HISTORIC AND DESIGN REVIEW COMMISSION

HDRC CASE NO: 2025-129
ADDRESS: 118 PARKVIEW DR
LEGAL DESCRIPTION: NCB 6919 BLK LOT 15 & W 12.5 FT OF 16
ZONING: R-5, H
CITY COUNCIL DIST.: 3
DISTRICT: Mission Historic District
APPLICANT: Analiza Alvarado
OWNER: Analiza Alvarado/ALVARADO ANALIZA
TYPE OF WORK: Construction of a 2-story, single-family residential structure
APPLICATION RECEIVED: May 15, 2025
60-DAY REVIEW: July 14, 2025
CASE MANAGER: Edward Hall

REQUEST:

Final Review: Response to Staff Stipulations

01 Street Height Context
SCALE 1" = 10'-0"

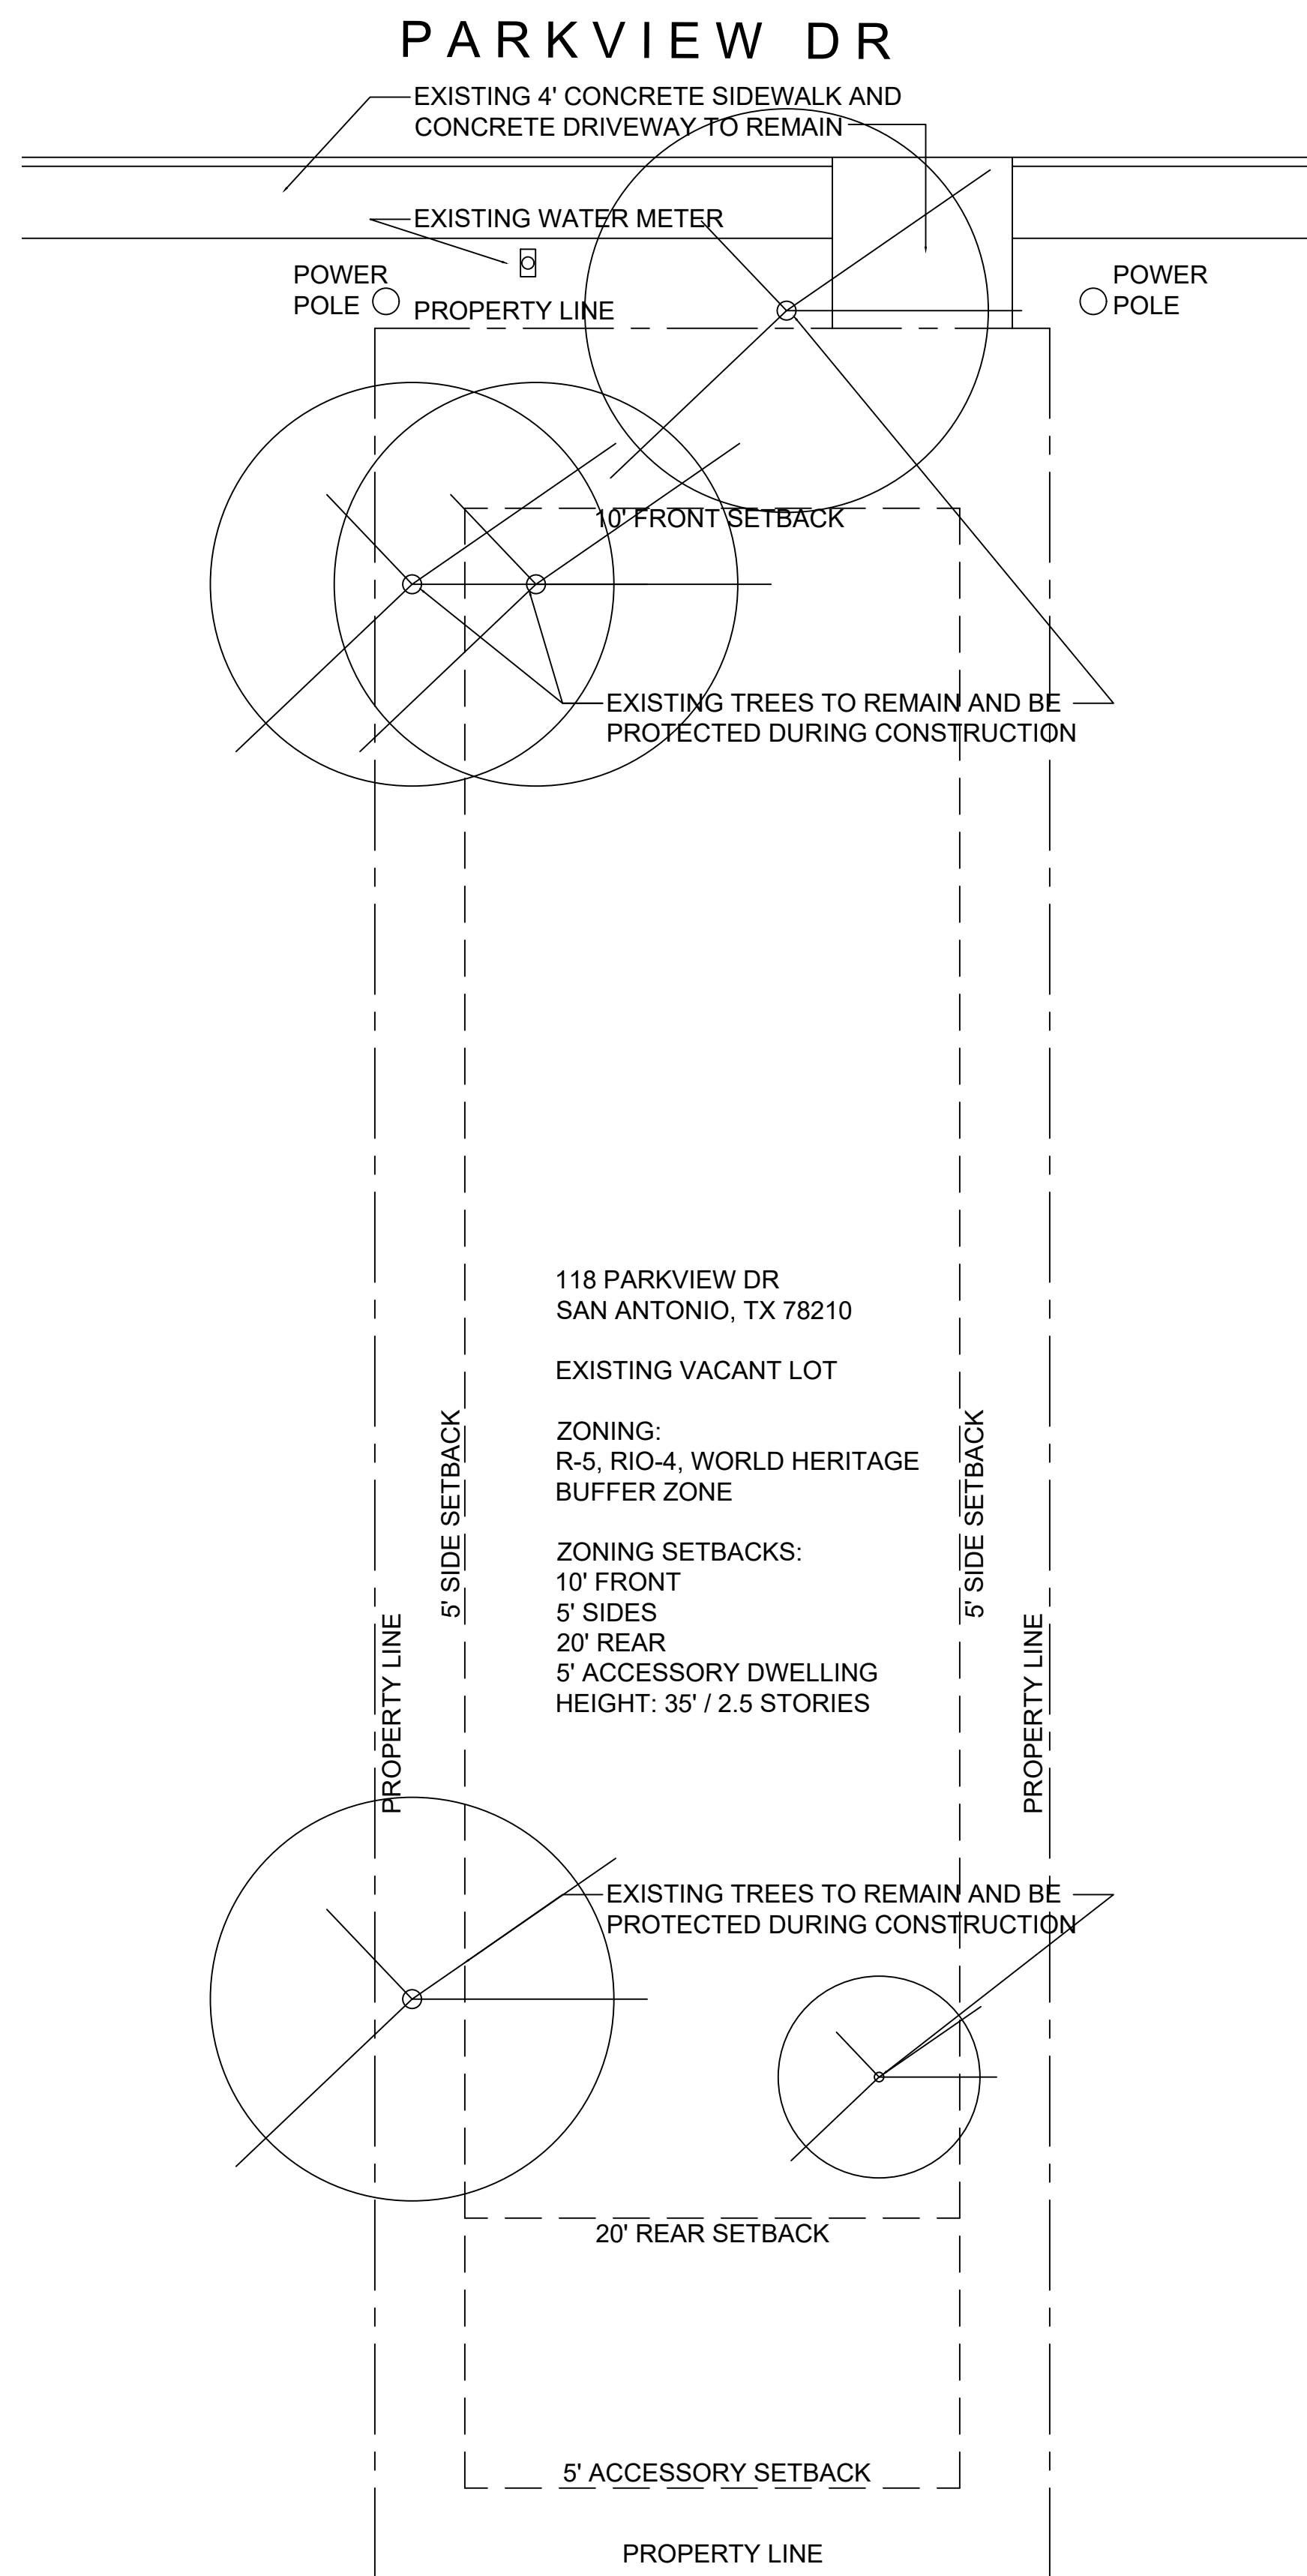
- ii. That measurements of the proposed structure's height as well as the adjacent structure's heights be provided to determine the appropriateness of the proposed height of 2-stories, provided that the total height does not exceed the height of adjacent structures by fifty (50) percent. ***This stipulation has been partially met.***

- f. **SCALE & MASS** – Per the Guidelines for New Construction 2.A.i., a height and massing similar to historic structures in the vicinity of the proposed new construction should be used. In residential districts, the height and scale of new construction should not exceed that of the majority of historic buildings by more than one-story. The applicant has proposed new construction that features 2-stories in height. Per the Guidelines, a 2-story structure may be appropriate provided that it does not exceed the height of adjacent structures by fifty (50) percent. The applicant has proposed a height of 26’ – 2”. The applicant has noted that the height of the two adjacent historic structures is between fifteen (15) and sixteen (16) feet in height. The applicant’s proposed height of 26’ – 2” exceeds the height recommended by the Guidelines. Staff finds that a hipped roof form would reduce the 2-story structure’s proposed height and massing in the context of the neighboring 1-story structures.

2. Height Comparisons

Response: The proposed roof peak is 26'-2" AFF, well within the 35' limit and under 50% taller than adjacent structures. See Sheets A4 (Elevations) and A5 (Sections) for height documentation.

02 proposed site plan
SCALE 1/8" = 1'-0"

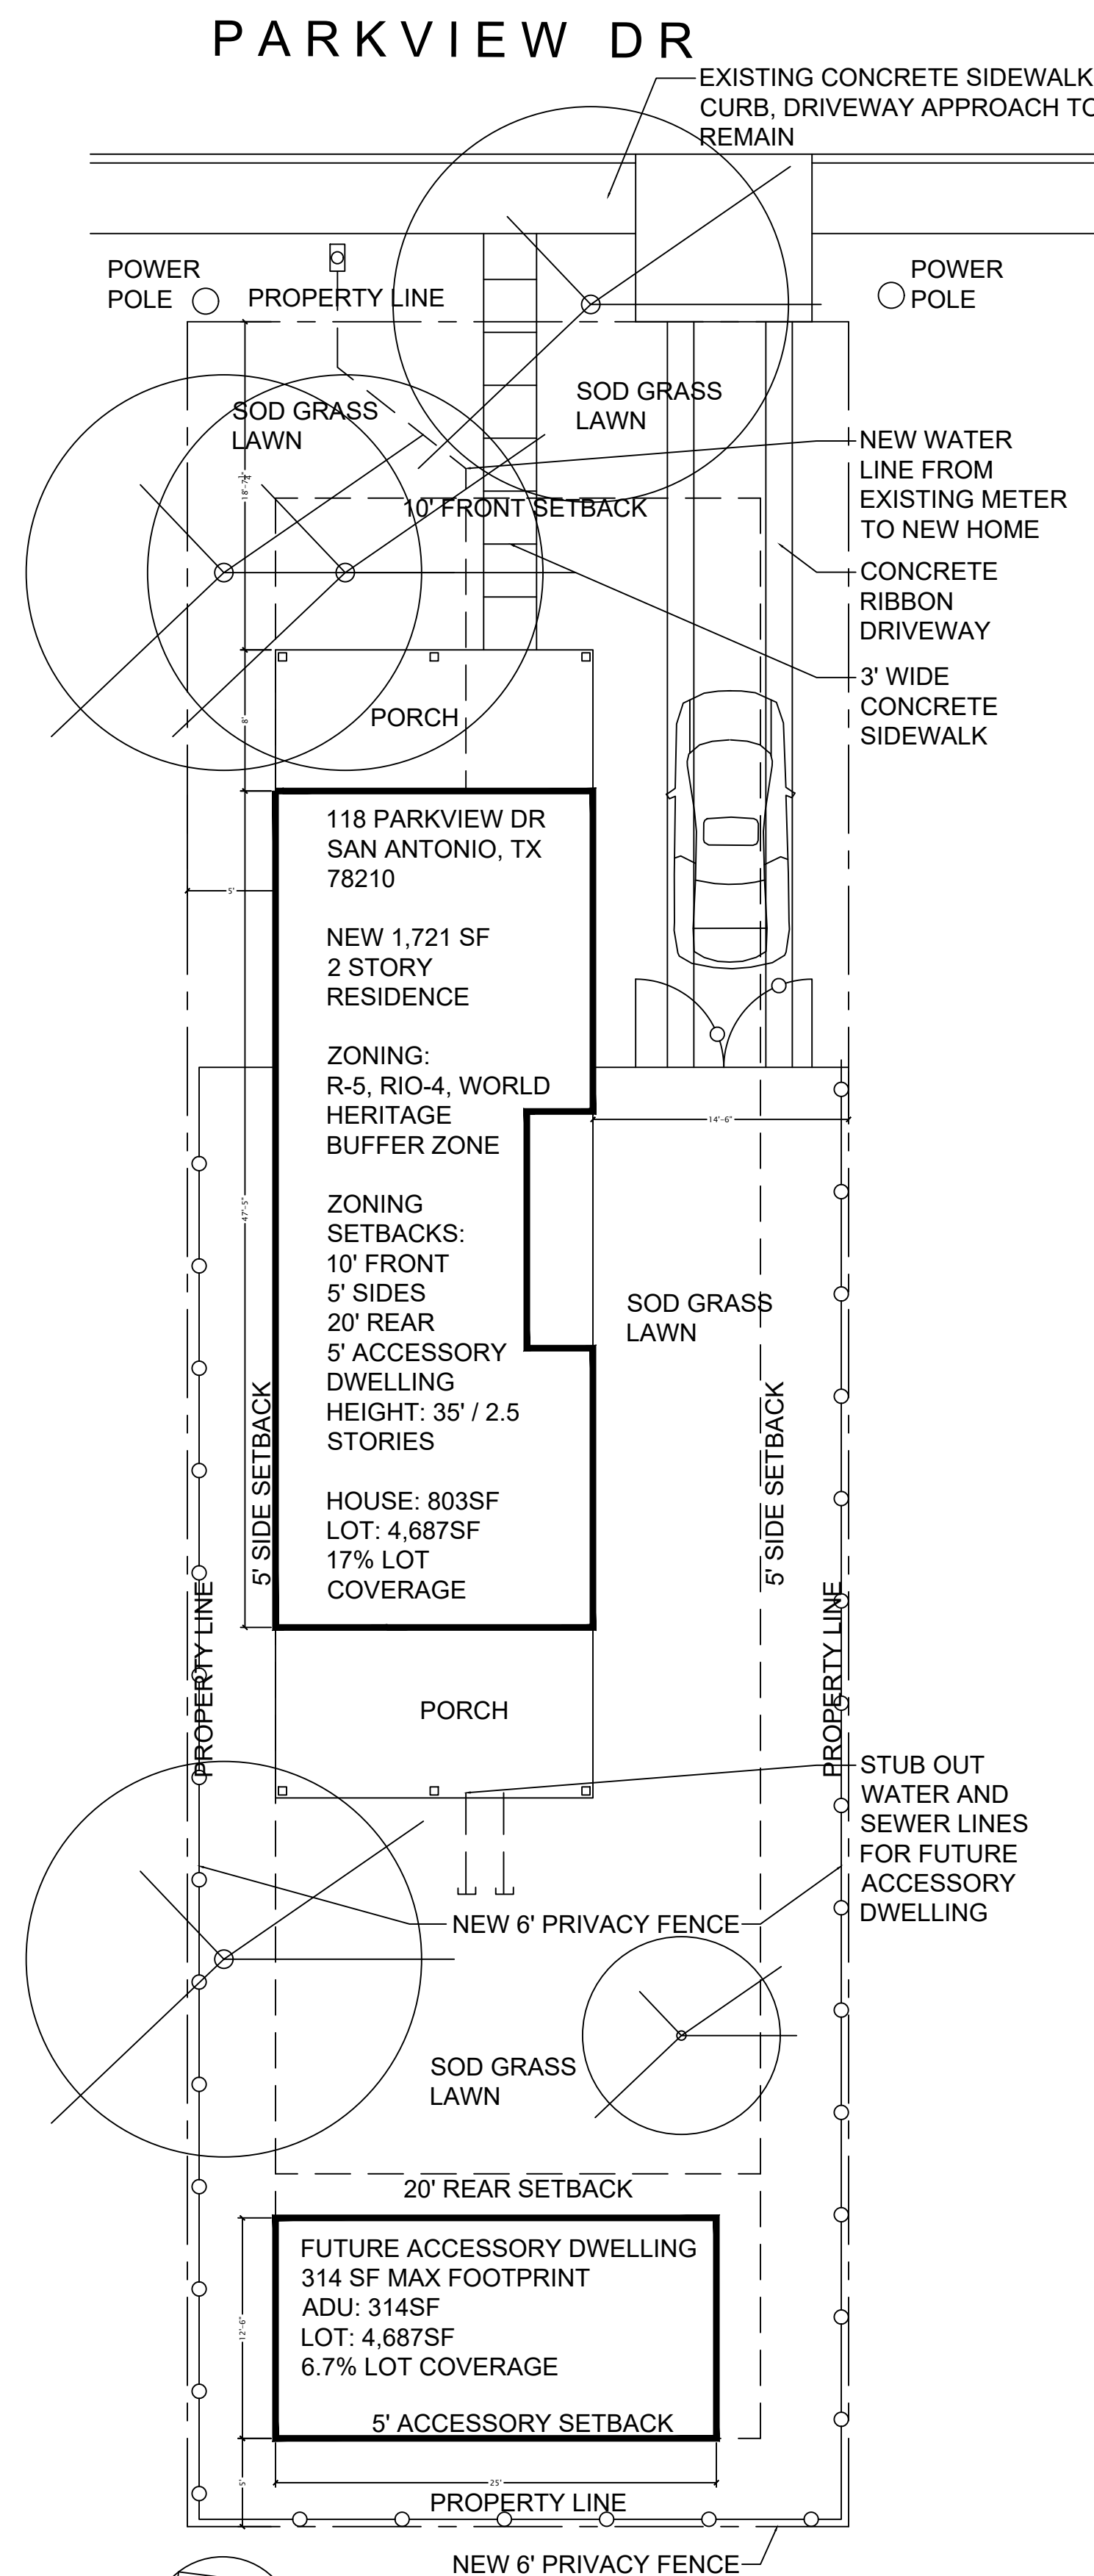
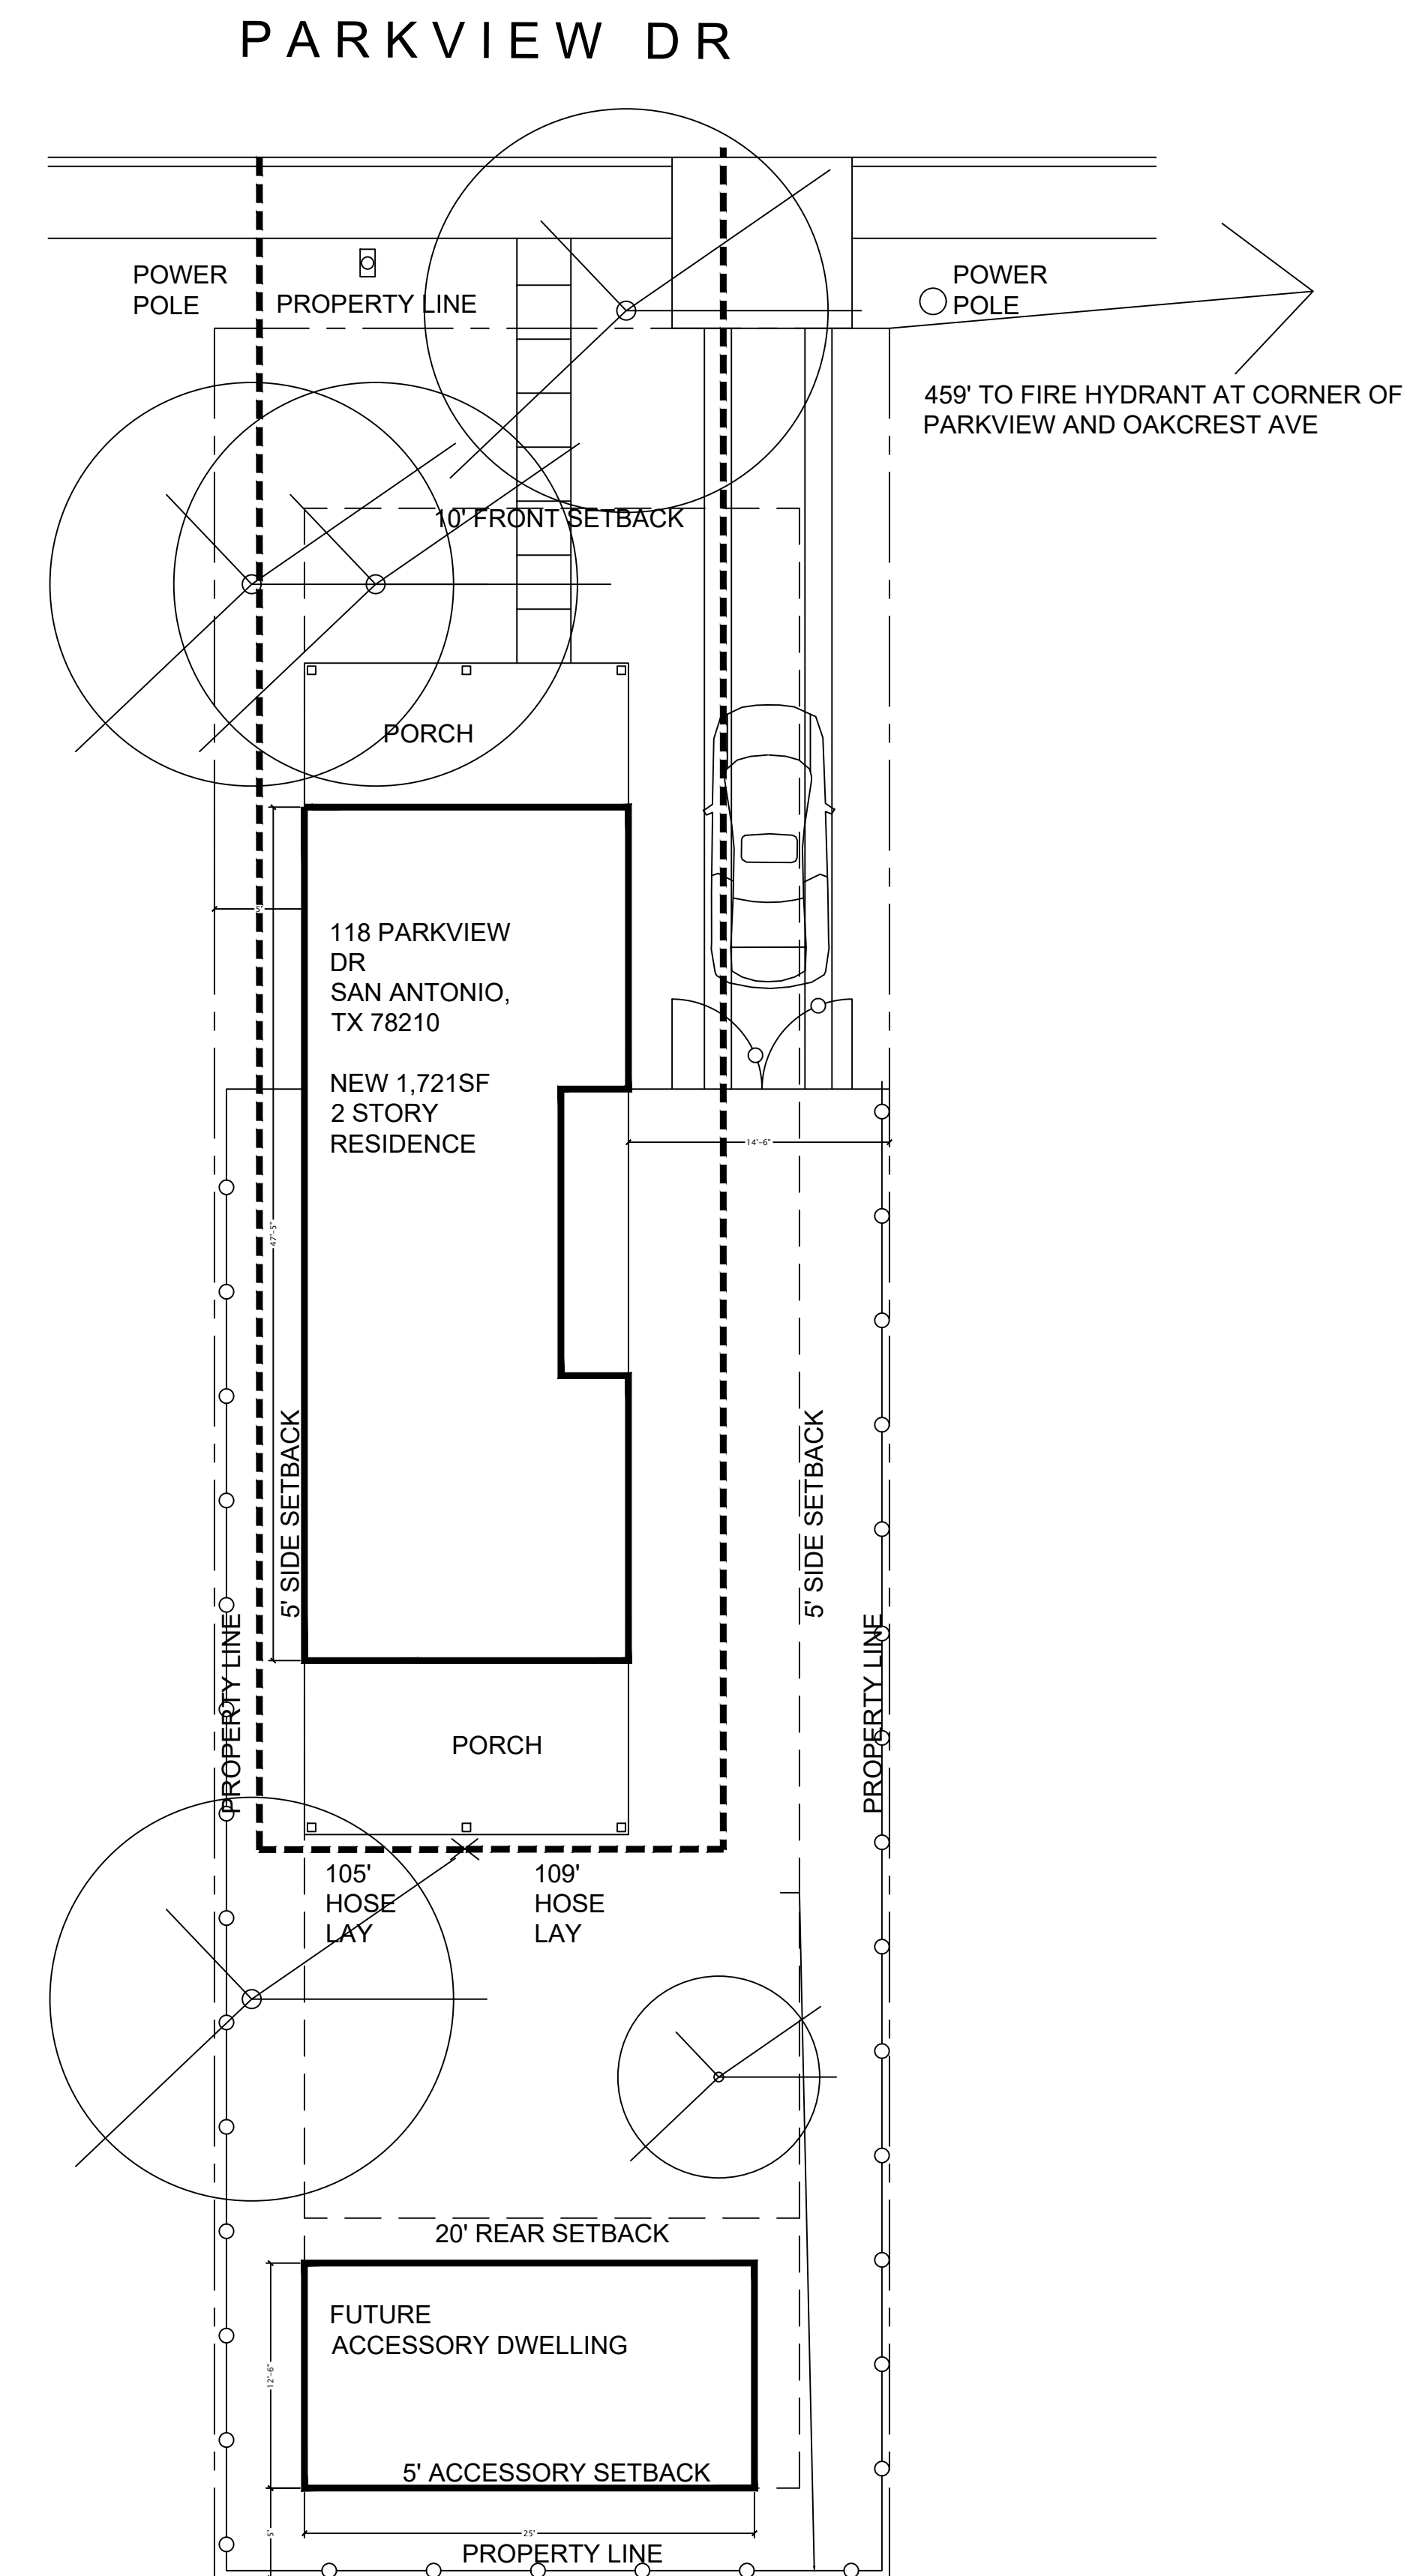
- i. That a setback that is greater than that of the neighboring two historic structures be incorporated, as noted in finding e. An increased setback would likely contribute to a reduction in perceived massing for the proposed 2-story structure. A setback diagram is to be provided to show the proposed new construction's setback in context with neighboring structures and the street, sidewalk, and property lines. ***This stipulation has been met.***

- viii. That the proposed driveway not exceed ten (10) feet in width and that the proposed walkway feature between three (3) and four (4) feet in width. ***This stipulation has been met.***

- ix. That a detailed landscaping plan be submitted when returning to the Commission for final approval that notes the location of fencing and provides information regarding landscaping materials. ***This stipulation has been met.***

- p. DRIVEWAY – The applicant has proposed a driveway on the east side of the lot. The applicant has not noted a driveway width. The Guidelines for Site Elements 5.A.i. notes that new driveway should incorporate a similar driveway configuration as to what is found historically. Typically, historic driveways are no wider than ten (10) feet in width. The applicant has proposed a driveway width of approximately seven (7) feet. This is consistent with the Guidelines.

Response: While the setback has not been increased beyond the original design, the proposed 21'-7" front setback still exceeds the 10' minimum requirement and is in line with the existing pattern of development on the street. Given the narrow width of the lot, this placement allows for necessary space in the rear and side yards, while maintaining visual consistency with the streetscape.

See Sheet A1 (Proposed Site Plan) for property line context and neighbor alignment.

5. Lot Coverage

Response: The footprint of the new home is 803 SF on a 4,687 SF lot (17% coverage), well under the 50% limit. See Sheet A1 (Proposed Site Plan).

8. Driveway and Walkway Width

Response: Driveway width is limited to 10', and walkway is 3' wide. See Sheet A1 (Proposed Site Plan).

Response: Landscape plan includes sodded lawn and future accessory dwelling with fencing locations marked. See Sheet A1 (Proposed Site Plan).
